SUBJECT: ISSUANCE OF AMENDMENT NO. 133 TO FACILITY OPERATING LICENSE NO. NPF-12 REGARDING POWER UPRATE - VIRGIL C. SUMMER NUCLEAR STATION, UNIT NO. 1 (TAC NO. M93404)

VIRGIL C. SUMMER NUCLEAR STATION, UNIT NO. 1

Amendment No. 133
License No. NPF-12

SAFETY EVALUATION BY THE OFFICE OF NUCLEAR REACTOR REGULATION

Figure 3.4-2 V. C. Summer Unit 1 Reactor Coolant System Heatup Limitations (Heat up rates up to 50 and 100°F/hr) Applicable for the First 13 EPFY (With Margins 10°F and 60 psig For Instrumentation Errors)

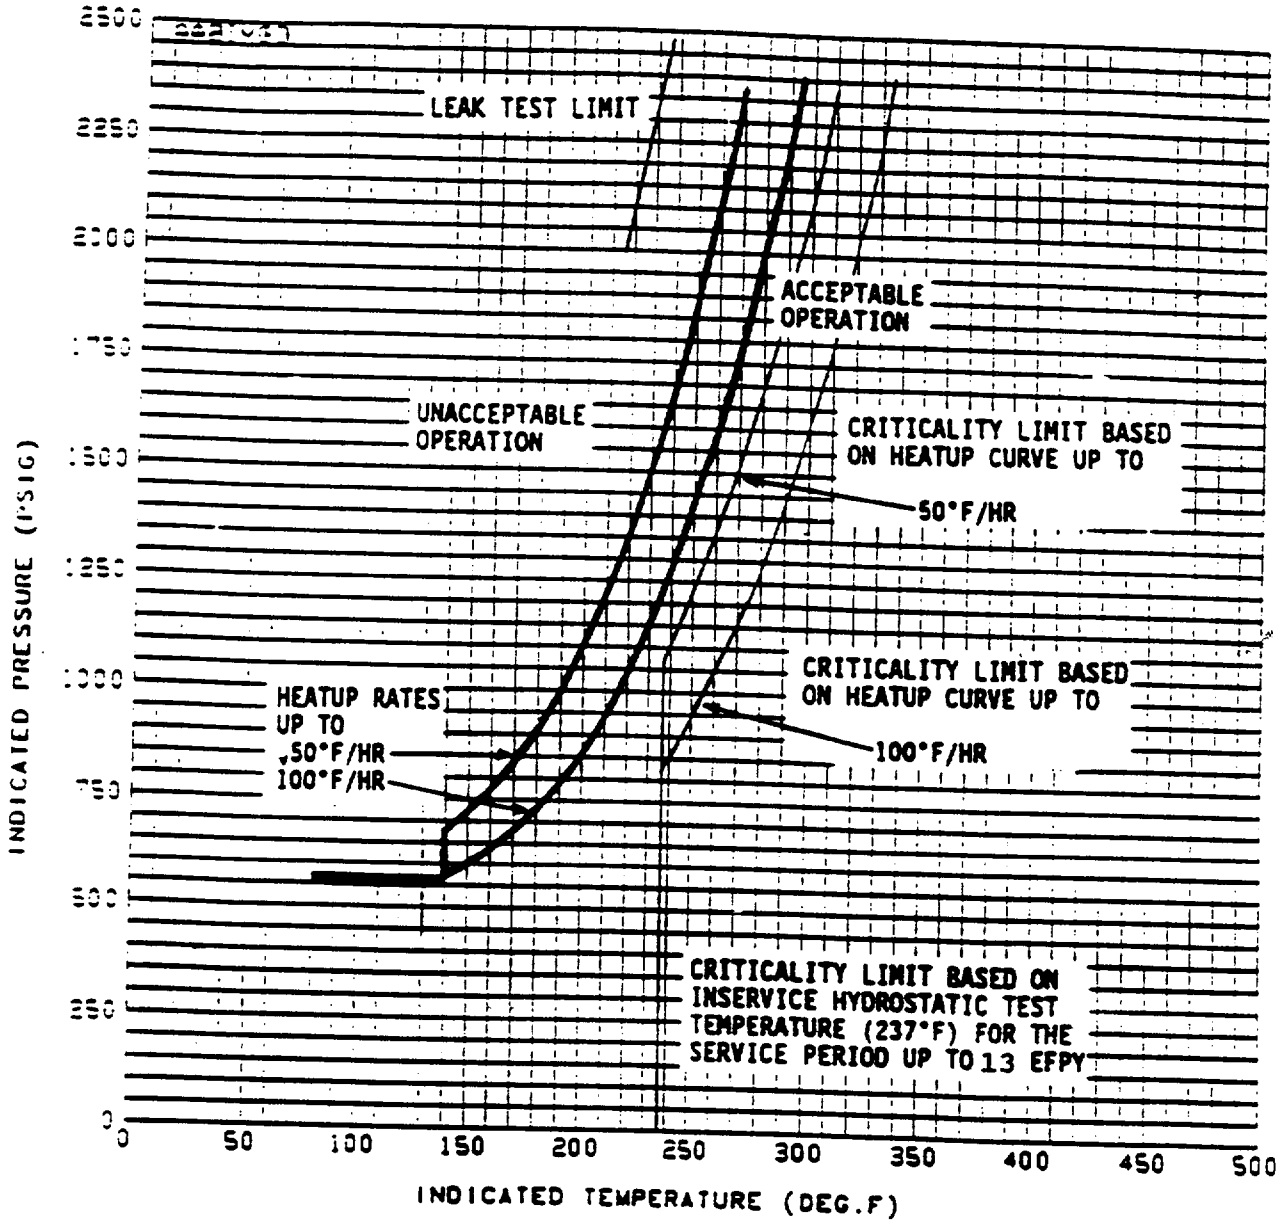
TS Figures 3.4-2 and 3.4-3 - Revise applicability from 14 effective full power years (EFPY) to 13 EFPY due to increased neutron fluence effect.

The licensee indicated the increase in core power will have an associated increase in the neutron fluence which interacts with the reactor vessel. To account for this increase in neutron fluence, the licensee has proposed changing the applicability of the TS heatup and cooldown curves (TS Figures 3.4-2 and 3.4-3, respectively) from 14 effective full power years (EFPY) to 13 EFPY. The staff agrees that a 1 EFPY reduction in applicability is appropriate for the proposed power uprate. Therefore, the licensee's requested TS changes are acceptable.

CONTROLLING MATERIAL: LOWER SHELL
INITIAL RT_{NDT}: 10°F
ART AFTER 13 EPFY: 1/4T, 96°F
3/4T, 83°F
